Development of Regulations 16 and 129

Packaging Assessment

OICA

GRSP ECRS 50th Informal Group – 18-19 March 2015

Geometry of the new booster fixture in comparison with the real life today: **compatibility issues**

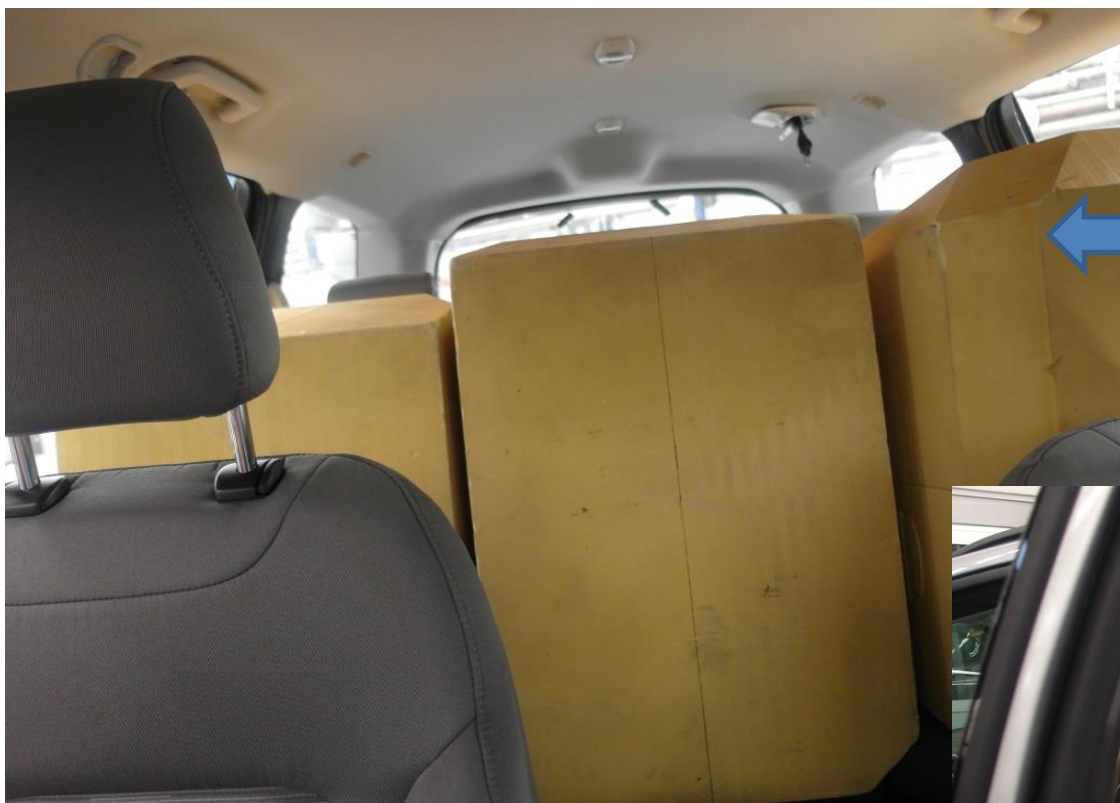
1. The width:

- head width
- max (shoulders) width
- hip width (for buckling)

2. The height:

- accepted without ISOFIX links
- child's head \leq 50% male's head

Front view + side view: Galaxy

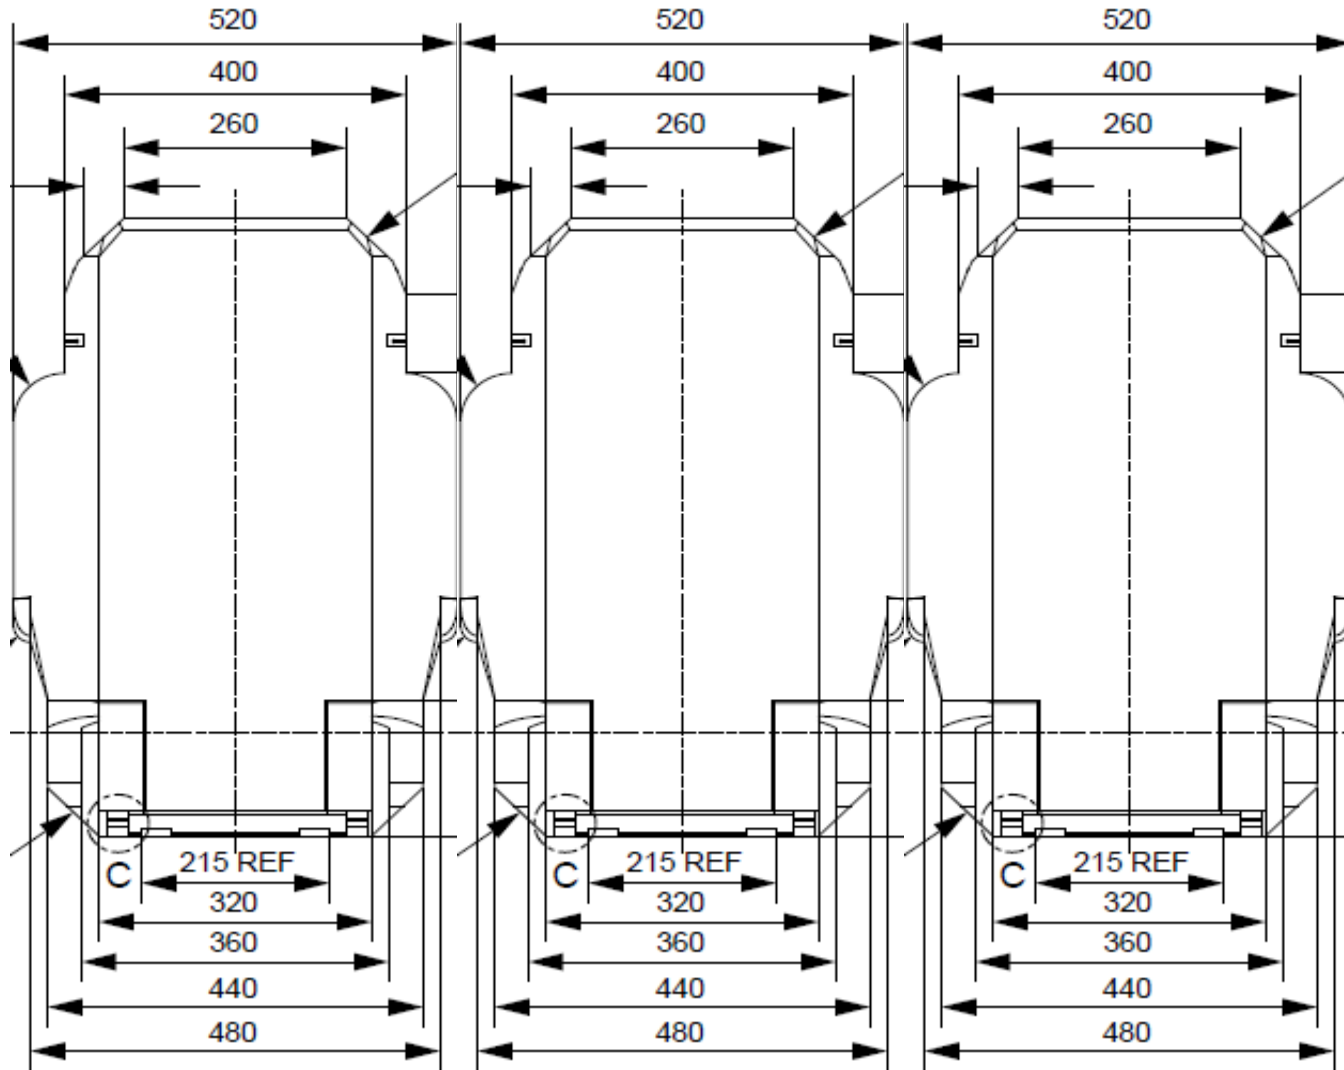
Maximum width of the fixture is too big?

Currently: no universal booster fixture is defined.

In future: maximum width could become **520mm**
=> 3 fixtures will not fit in most family cars.

← These are 440 mm ISO gabarits

Which vehicles have the room for 3 Universal Booster Gabarits in 2nd Row?

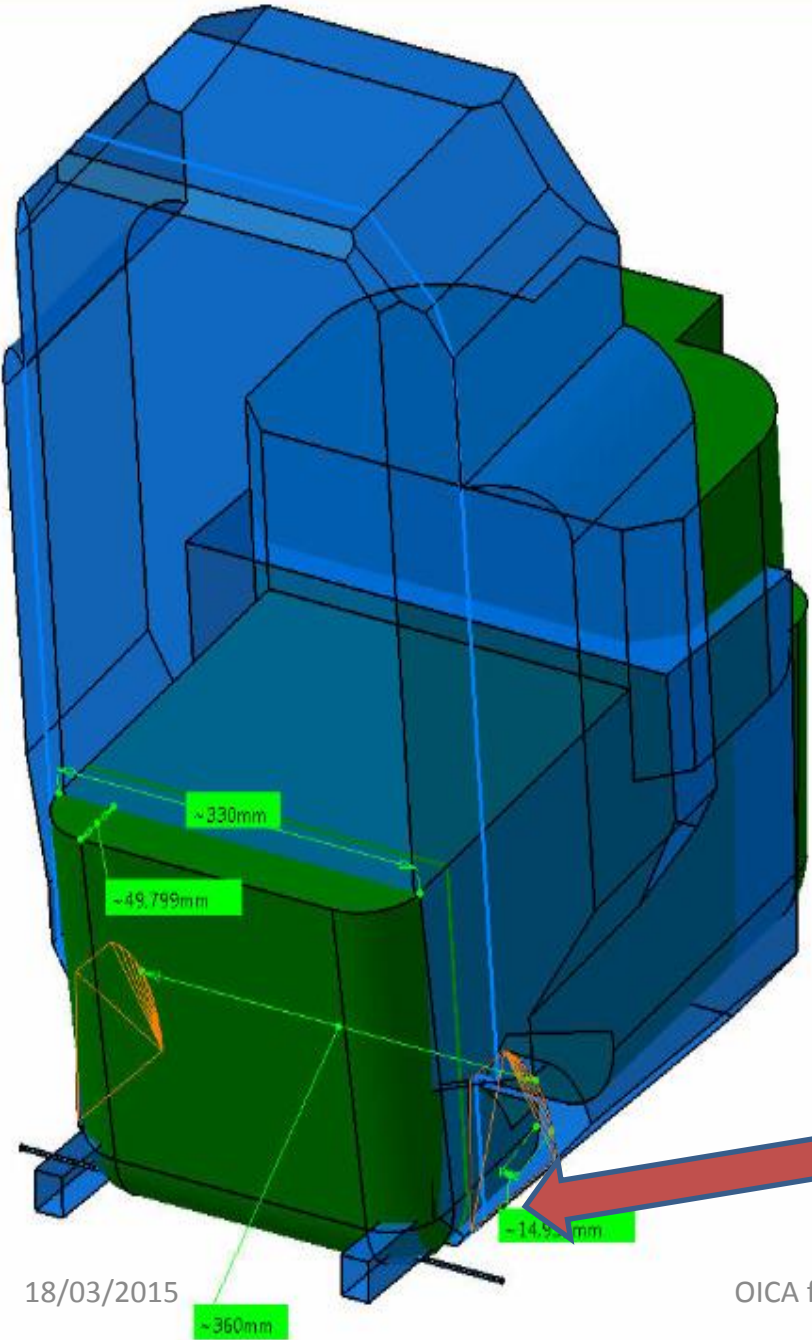
3 Boosters
Total width
3 x 520 mm
= **1560mm**

Comparison of one of the proposed ISO booster gabarit with R16 universal gabarit

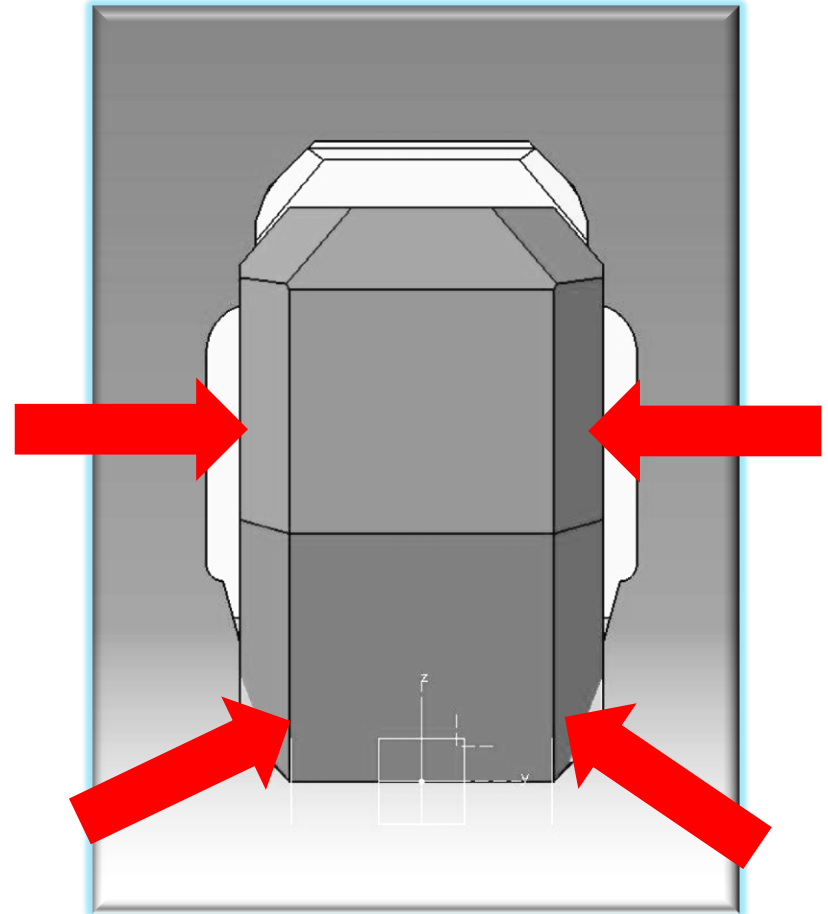
⇒ Too wide
⇒ ISOFIX not needed

Proposal: smaller gabarit

⇒ max width= 440mm
with buckling access
